PRODUCT CHANGE NOTIFICATION

E-Switch Series/ Part No affected:
P040038, P040040, P020092, P040039

Part /Series Description:
EG1218 Series

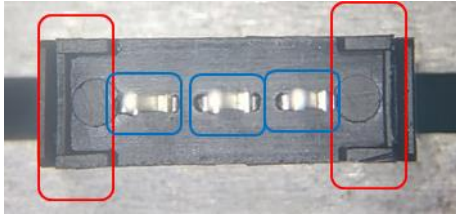
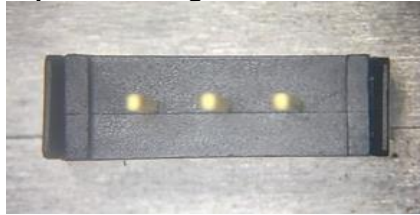
1. Increase productivity
2. Reduce semi hazardous substance (epoxy) to meet the needs of environmental protection

1. **Current manufacturing has the terminals pressed into switch base and then epoxy around terminals. The process change is to insert mold the terminals into the switch base. This will eliminate the need for epoxy on the bottom of the switch**

Proposed Transition/change over: This will be a "running" change since the new inserted molded base does affect any type of "Form, Fit, or Function" of the switch and there isn't any change to any of the switch specifications.
